Application for change or cancellation of resource consent condition (S.127)

Pursuant to Section 127 of the Resource Management Act, the Applicant is seeking to vary the conditions of RC 2300599 - RMALUC which established a residential dwelling within the site legally described as Lot 43 DP 384236. The application was assessed as a Discretionary Activity within the Coastal Living zone under the Operative District Plan (ODP). Consent was granted on 22nd June 2021.

- 1.1. Pursuant to Section 127 of the Resource Management Act, the Applicant is seeking to vary Conditions 1, 4, 5 & 6 of resource consent RC 2300599 - RMALUC which was required to establish a dwelling on the site located in the Coastal Living zone. The proposal breached Visual Amenity, Sunlight, Stormwater Management and Setback from boundaries and was assessed as a Discretionary Activity under the Operative District Plan (ODP). A variation to Condition 10 within Consent Notice 7389051.2 was also sought to enable the option to use storage tanks for firefighting water supply or have a domestic sprinkler system installed. The consent was approved on 22nd June 2021.

Figure 1: Site Plan showing proposed basement alteration and location of new concrete area around the existing garage.

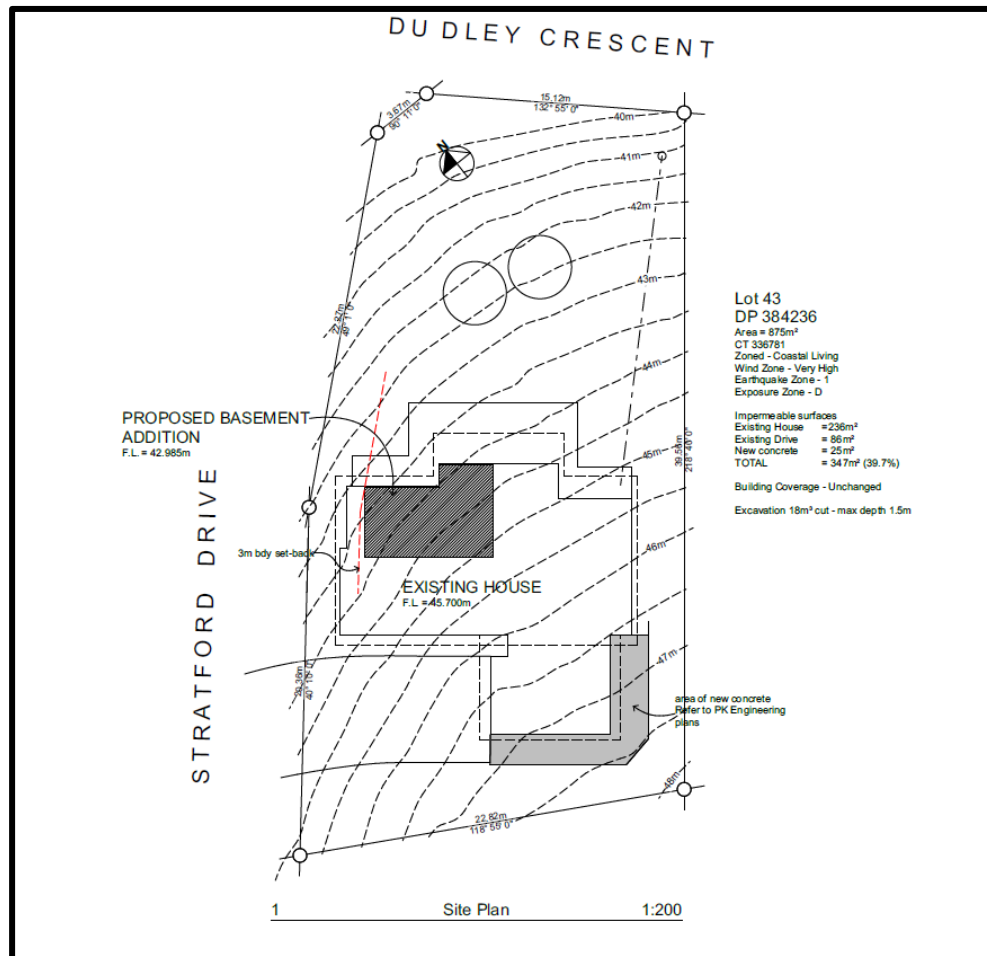
- 1.2. The Applicant is proposing to enclose the lower storey of the existing dwelling to include one bedroom with ensuite and a games room. This alteration will be utilised in association with the upper storey unit. The Plan Set showing the proposed alterations is contained within **Appendix 5**, prepared by Total Design. These works are anticipated to begin within the next 1-2 years.

- 1.4. Approximately 25m² of new concrete has also been added around the garage which slightly increases the amount of impermeable surfaces. The approved amount of impermeable surfaces under RC 2300599 was 322m² or 36.8% of the total site area and was assessed as a Discretionary Activity. The additional concerted area will increase by 25m² bringing the total impermeable surfaces on site to 347m² or 39.6%. This does not alter the activity status or degree of non-compliance applied for in relation to impermeable surfaces. An updated Stormwater Management Report (SMR) has been prepared by PK Engineering to address this and is attached within **Appendix 7**.

Figure 3: Proposed altered landscape plan.

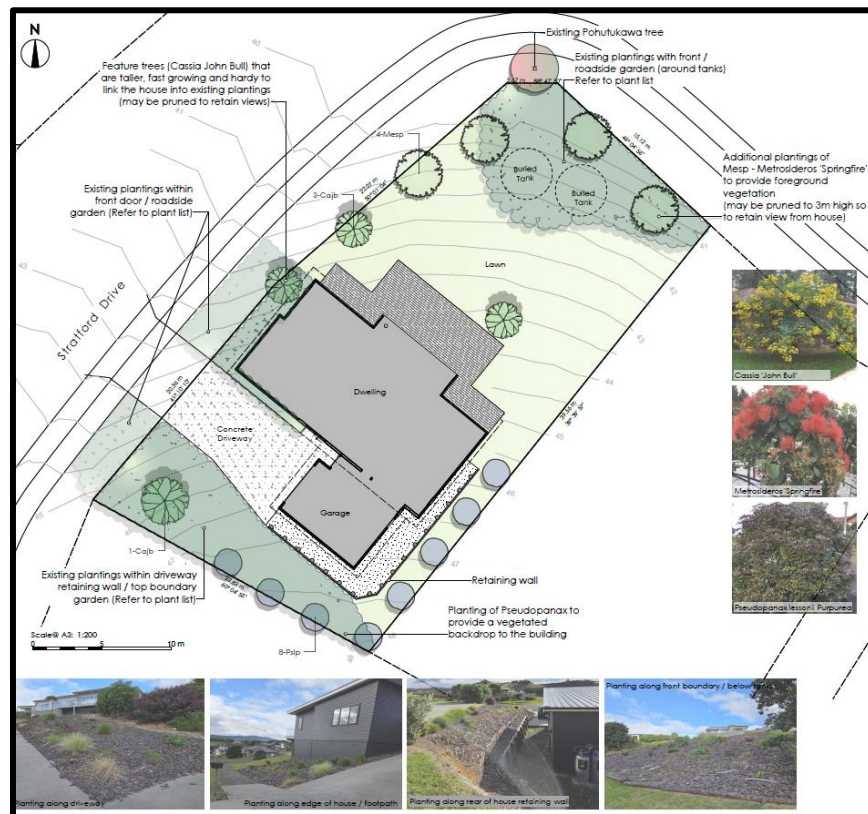
- 1.3. It is also proposed to alter the approved landscaping previously approved under RC 2300599. An updated Landscape Plan (**Appendix 6**) has been prepared by Hawthorn Landscape Architects which reflects a reduced amount of planting within the site, given that under the Proposed District Plan – Appeals Version (PDP-AV), the site is not located within the Coastal Environment.

- 4.5. The reduced landscaping has been assessed as appropriate given that the site is not located within the Coastal Environment under the RPSN Maps or the PDP-AV maps. The dwelling exterior will continue to utilise a natural recessive colour scheme and the lower storey extension will utilise the same cladding and colour scheme to provide coherence and be visually appealing. The proposed landscaping will compliment this. In terms of visual effects, these are considered to be less than minor as well as effects on character and amenity. Landscaping will still be provided for, with the Landscaping Plan being prepared by a Landscape Architect and the dwelling will utilise a natural recessive colour scheme as well as any concreted surfaces being tinted.

- Condition 4 – Implementation of the landscape plan prepared by Hawthorn Landscape Architects, dated ~~14 March 2021, provided with RMA LUC 2300599~~ **15/06/2026** is to be undertaken within the first two planting seasons (approximately March-September) directly following commencement of any of the works relating to this **approved variation** consent and maintained by the consent holder thereafter, all to the satisfaction of the Far North District Council's Monitoring Manager or duly delegated officer.
